**METROPOLITAN GOVERNMENT OF NASHVILLE AND DAVIDSON COUNTY**

**STAFF RECOMMENDATION**  
**503 Buchanan Street**  
**May 16, 2018**

**Application:** New construction—infill and outbuilding  
**District:** Salemtown Neighborhood Conservation Zoning Overlay  
**Council District:** 19  
**Map and Parcel Number:** 08108046500  
**Applicant:** Will Jenner  
**Project Lead:** Paul Hoffman, paul.hoffman@nashville.gov

<p><b>Description of Project:</b> Infill construction of a new residence on vacant lot.</p> <p><b>Recommendation Summary:</b> Staff recommends approval of the project with the following conditions:</p> <ol style="list-style-type: none"><li>1. The finished floor height is consistent with the finished floor heights of the adjacent historic houses, to be verified by MHZC staff in the field;</li><li>2. The front setback is consistent with the setbacks of the adjacent historic houses, to be verified by MHZC staff in the field;</li><li>3. The side dormers be removed;</li><li>4. The massing of the roof form be reduced;</li><li>5. The front porch be a minimum of six feet (6') deep;</li><li>6. A window or windows be added to the left side;</li><li>7. Staff approve a sample of brick

SITE PLAN

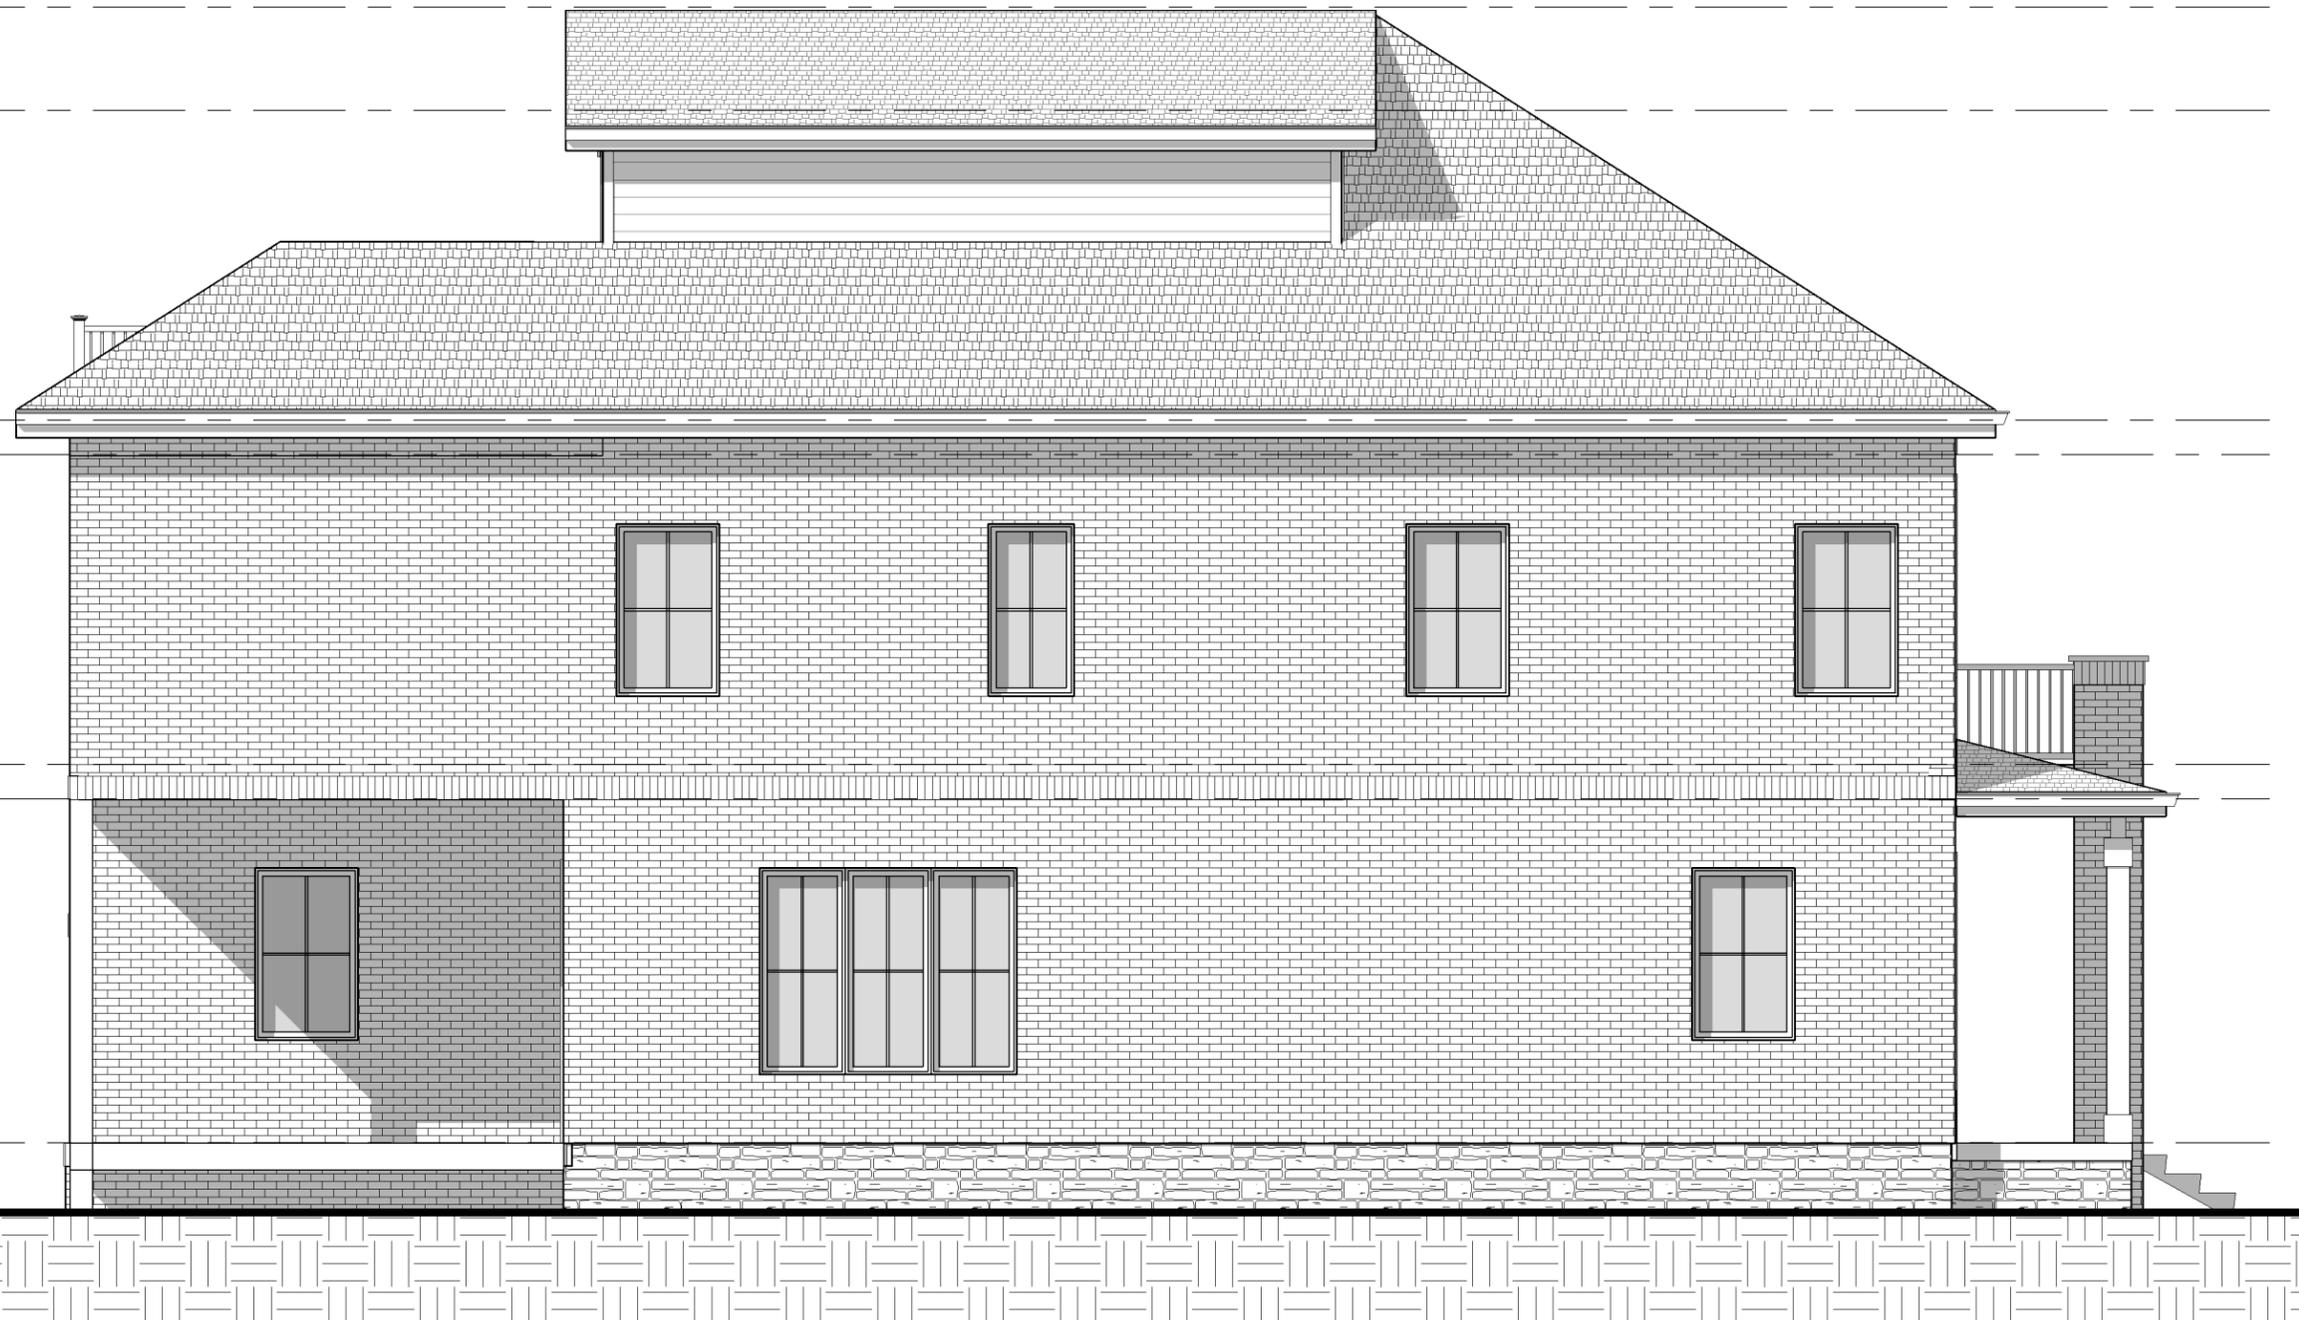
**Setback & Rhythm of Spacing:** The new building will be five feet (5') from the side property lines and twenty feet (20') from the rear property line. The front setback is seventeen feet, eight inches (17' 8"). This is slightly forward of the non-contributing building to its right, but matches the front setback of the nearest contributing building on this block. Staff recommends that the appropriate front setback be field checked before construction begins. The infill meets Section III.C of the design guidelines.

Orientation: The new structure will be oriented with the primary entrance facing Buchanan Street, which is appropriate. The site plan does not indicate walkways or driveways. Staff recommends walkways and driveways be added to the site plan, prior to construction. The front porch is drawn at five feet (5’) deep; the design guidelines require that porches should be at least six feet (6’) deep. Staff recommends that the porch be a minimum of six feet (6’) deep. Vehicular access to the site will be via the alley. With the conditions that the porch is six feet (6’) deep, and walkways and driveways are added to the site plan, Staff finds that the infill will meet Section III.F.

1. The finished floor height is consistent with the finished floor heights of the adjacent historic houses, to be verified by MHZC staff in the field;
2. The front setback is consistent with the setbacks of the adjacent historic houses, to be verified by MHZC staff in the field;
3. The side dormers be removed;
4. The massing of the roof form be reduced;
5. The front porch be a minimum of six feet (6') deep;
6. A window or windows be added to the left side;
7. Staff approve a sample of brick and stone;
8. Staff approve the roofing color, windows and doors, and material of driveways and walkways;
9. Driveways and walkways are added to the site plan; and
10. The HVAC be located behind the house or on either side, beyond the mid-point of the house.

FRONT ELEVATION

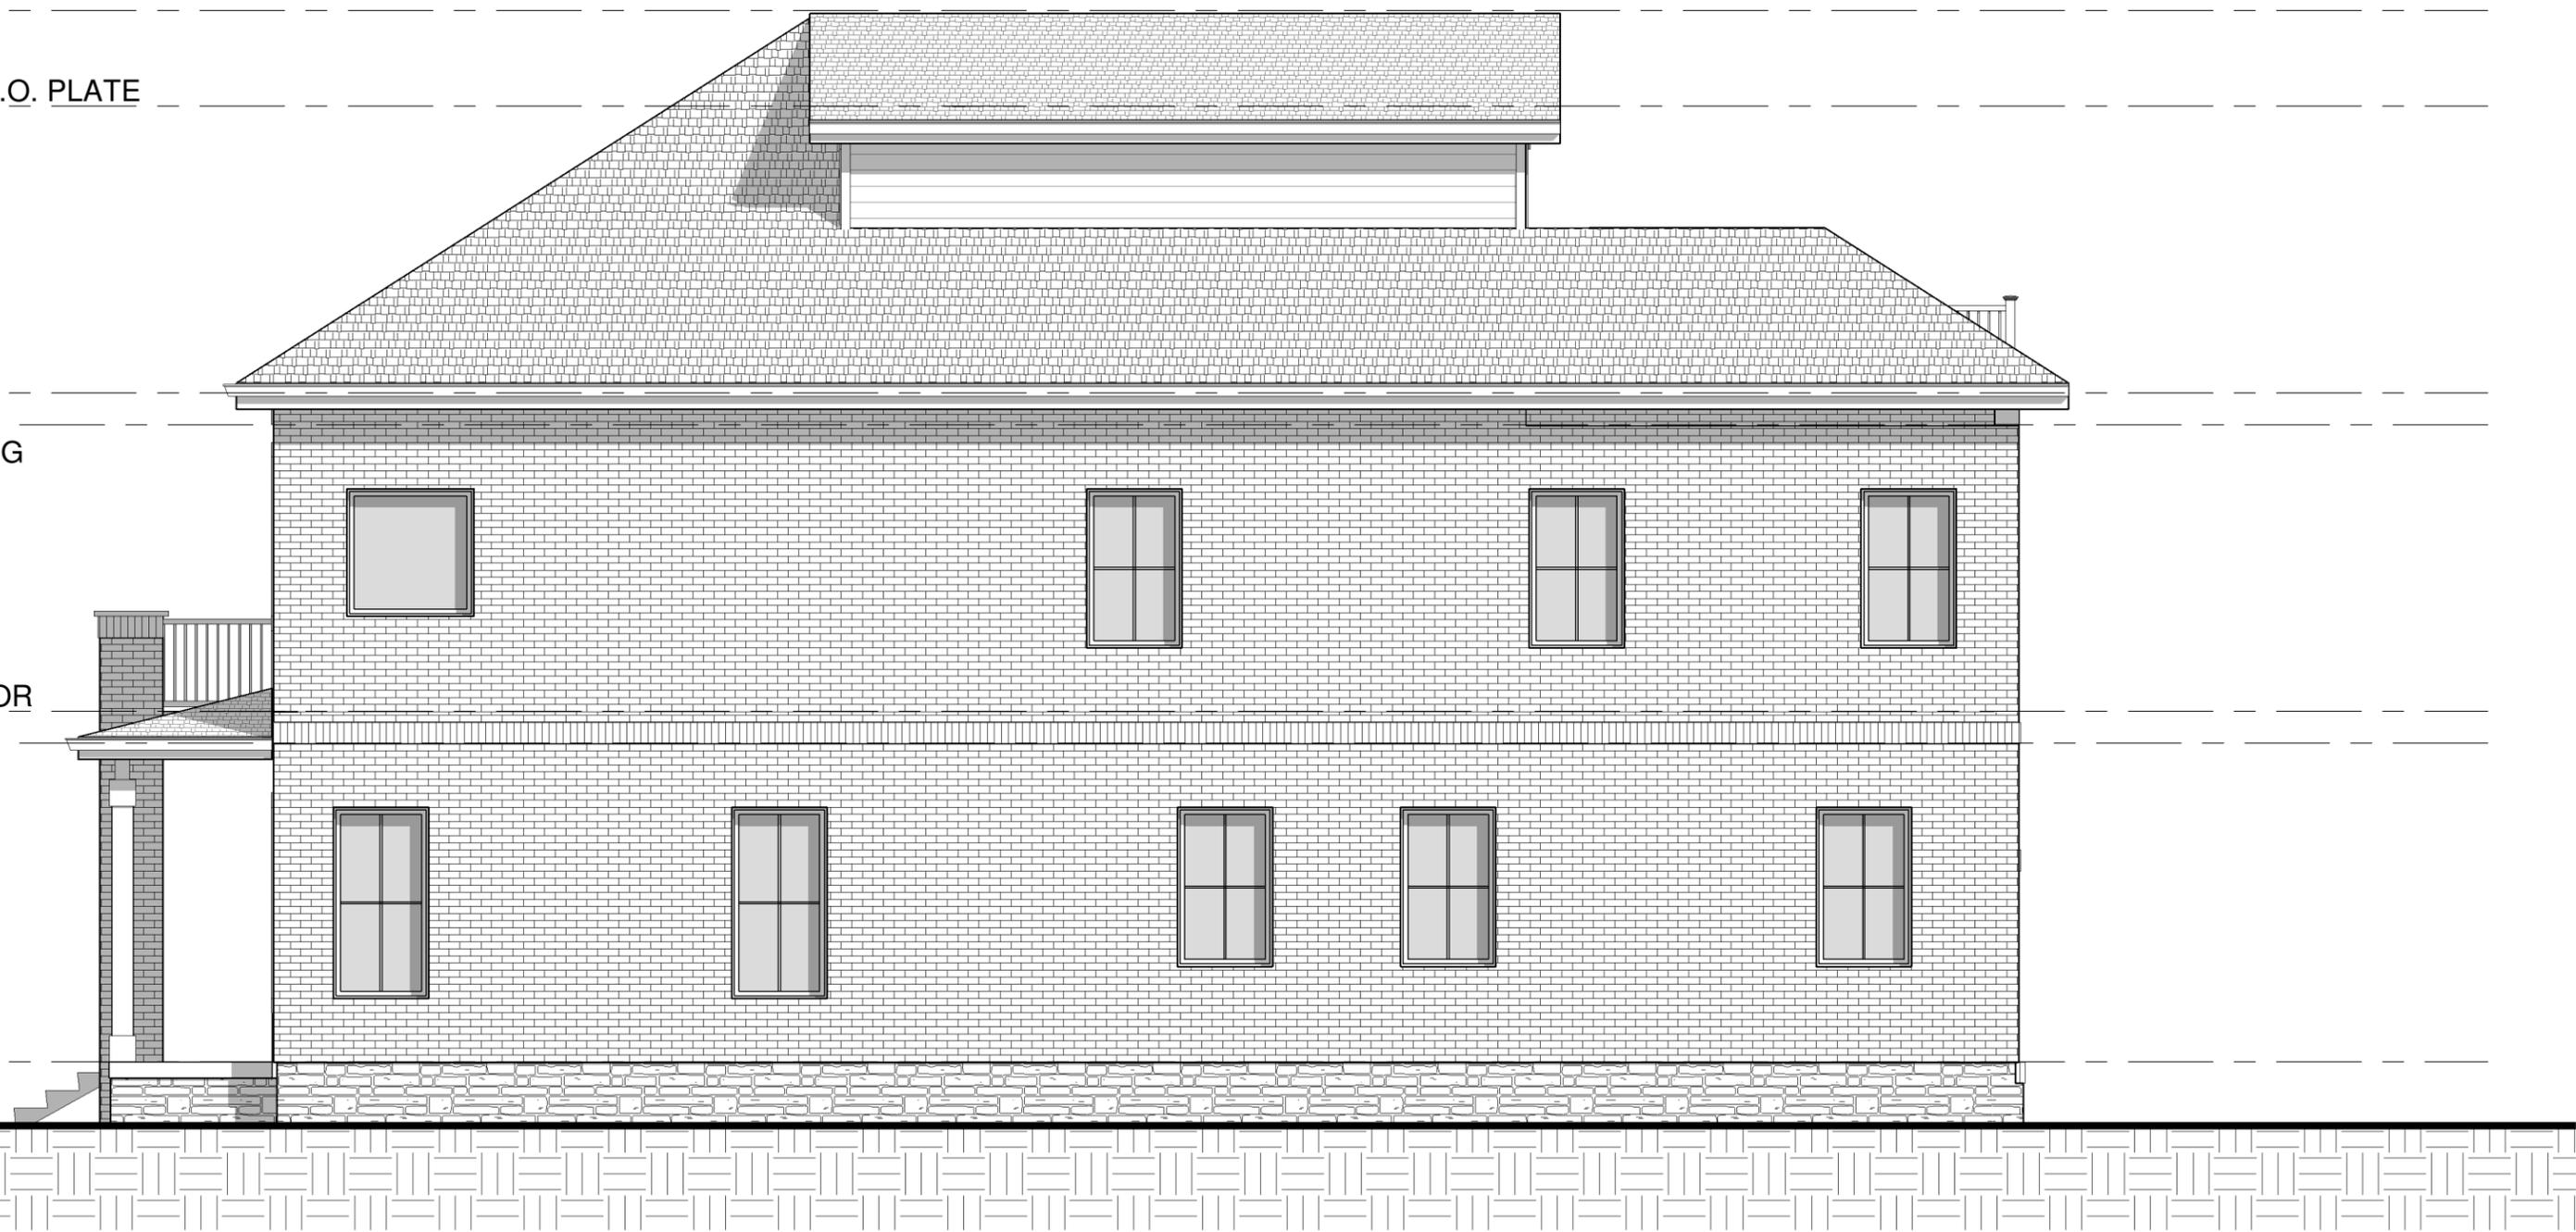
Height & Scale: The new building will have a maximum ridge height of thirty-four feet, nine inches (34' 9") from grade and an eave height of twenty-two feet (22'). The Commission has approved recent infill in Salemtown up to thirty-five feet (35') with similar eave heights between twenty and twenty-two feet (20' - 22'). Staff finds that these heights meet the design guidelines and the neighborhood context.

Large side dormers, especially those without windows, on tall roofs are not typical on historic buildings in this district. The proposed side dormers give the infill the appearance of a two-and-a-half story house with a roof form that it is inappropriate for the district, whereas the historic context is one and one-half stories. There are no two-and-a-half story historic houses in the Salemtown Neighborhood Conservation Zoning Overlay and there is only one two-story historic home. All infill development that has been approved by MHZC since the overlay has been two stories or less. In this case, the dormers add perceived height, give the infill a two-and-a-half story form and create an inappropriate roof form; therefore, staff recommends that they be removed and the roof form altered. (See also section on Roof Form.)

Roof form: The proposed infill has a hipped roof form with 7.5/12 pitch. As mentioned under “Height and Scale,” the side dormers add to the building’s perceived height and together with the massive roof form, create a two-and-a-half story building that does not meet the historic context. Staff therefore recommends that the dormers be removed and the massing of the roof form reduced to better meet the historic context. At the rear, the upper portion of the roof is open in order to create a rooftop terrace above the second story. Since the rooftop terrace is at the back of the house and will not be highly visible from the street, staff finds it to be appropriate; however, the roof form itself is too massive. Changing the massing of the roof form will alter and possibly eliminate the ability to have a door onto the deck. With the removal of the dormers and a reduction in the roof massing, staff finds that the project’s roof form could meet Section III.E of the design guidelines.

LEFT ELEVATION

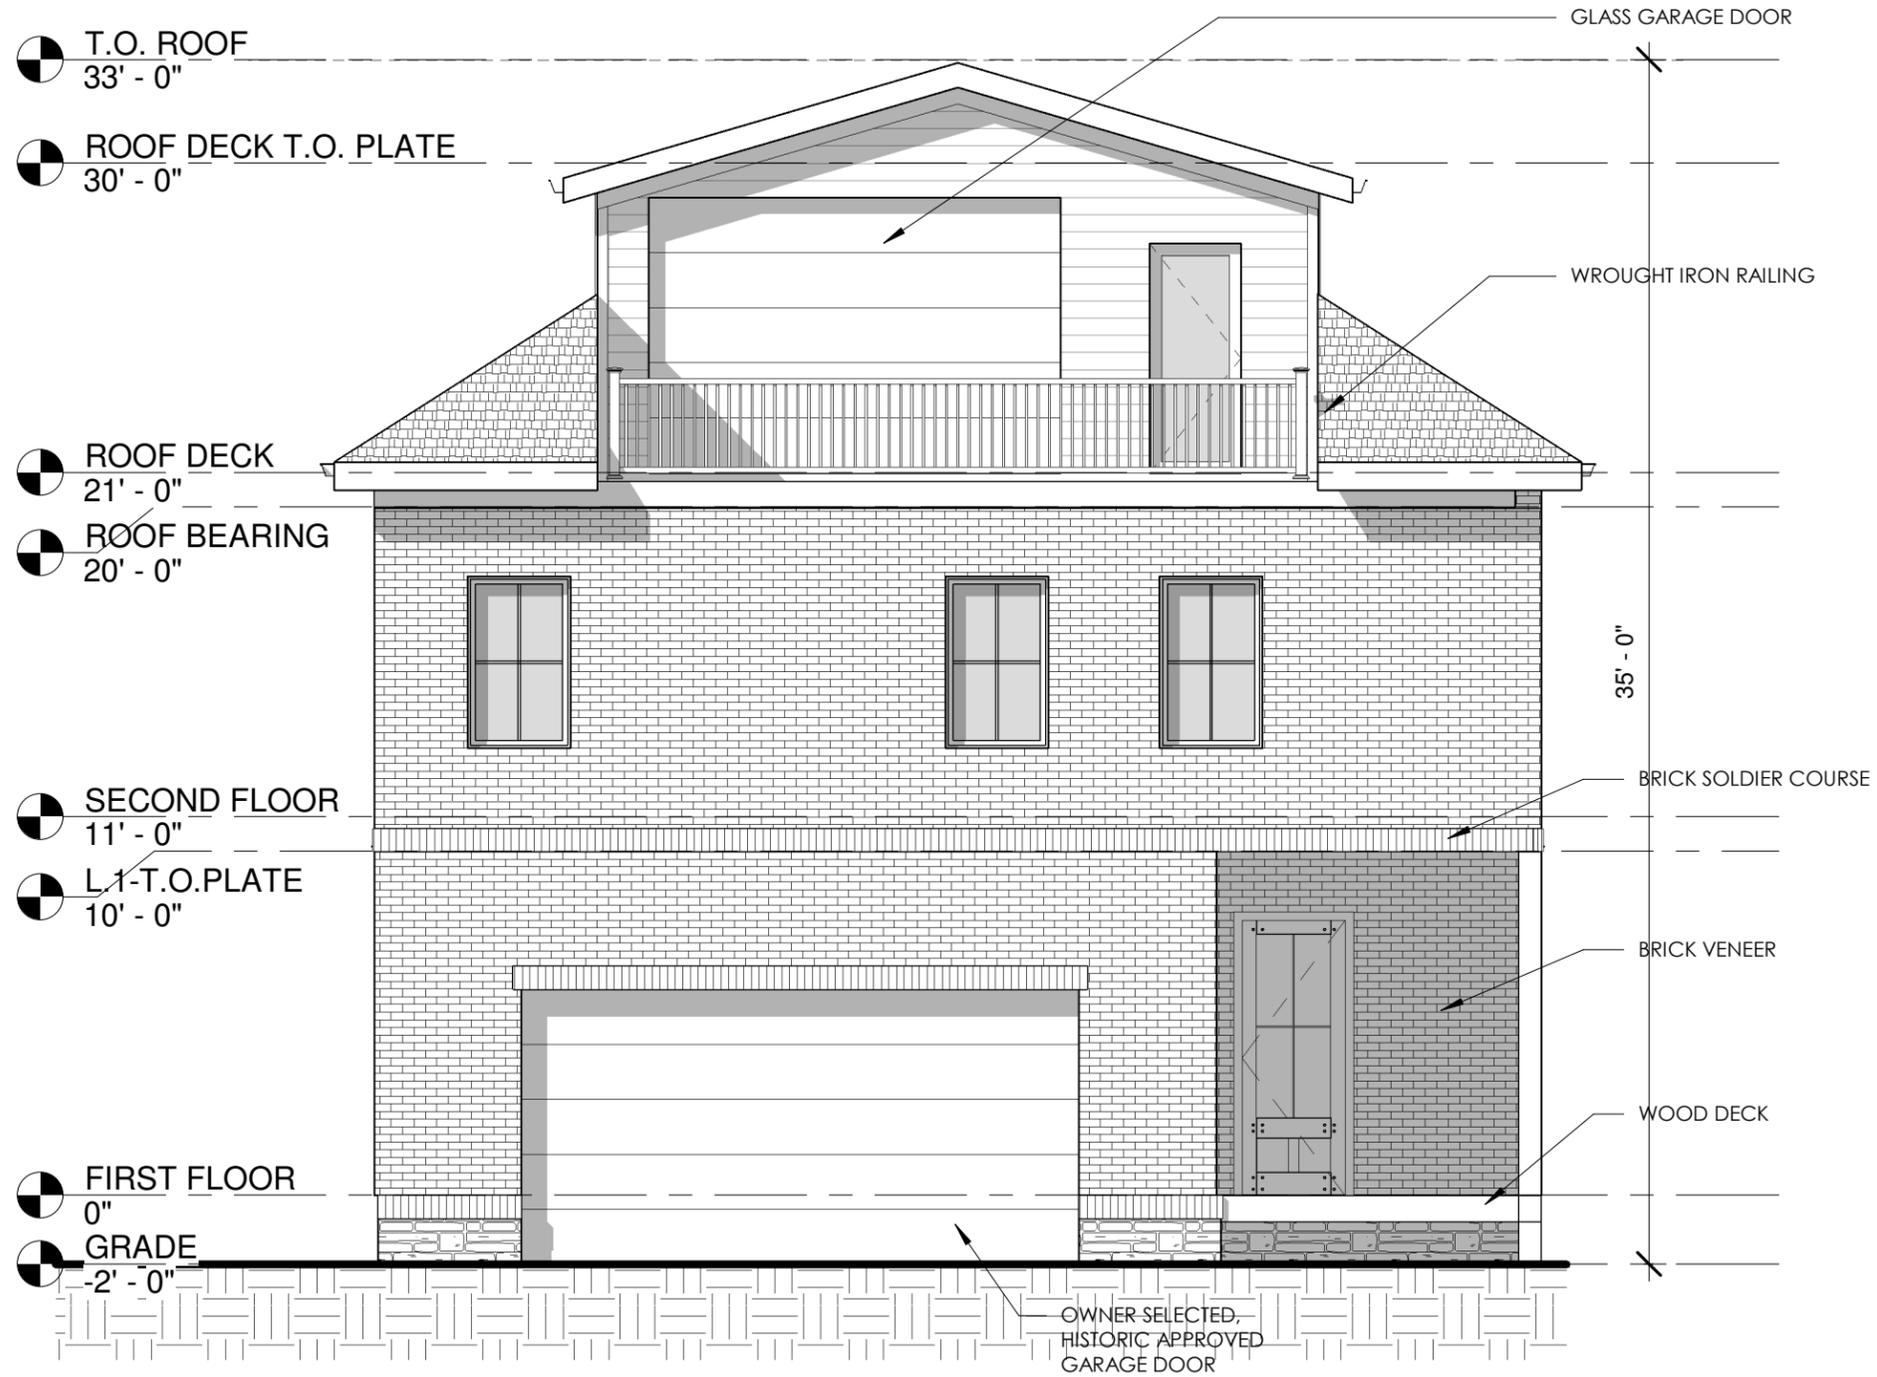
Proportion and Rhythm of Openings: The windows are generally twice as tall as they are wide, thereby meeting the historic proportion of window openings. The longest expanse of wall space without a door or window opening is nineteen feet (19’) on the building’s left side. Staff recommends adding a window or windows in this area to break up the blank wall area. With this condition the infill’s fenestration pattern meets Section III.G.
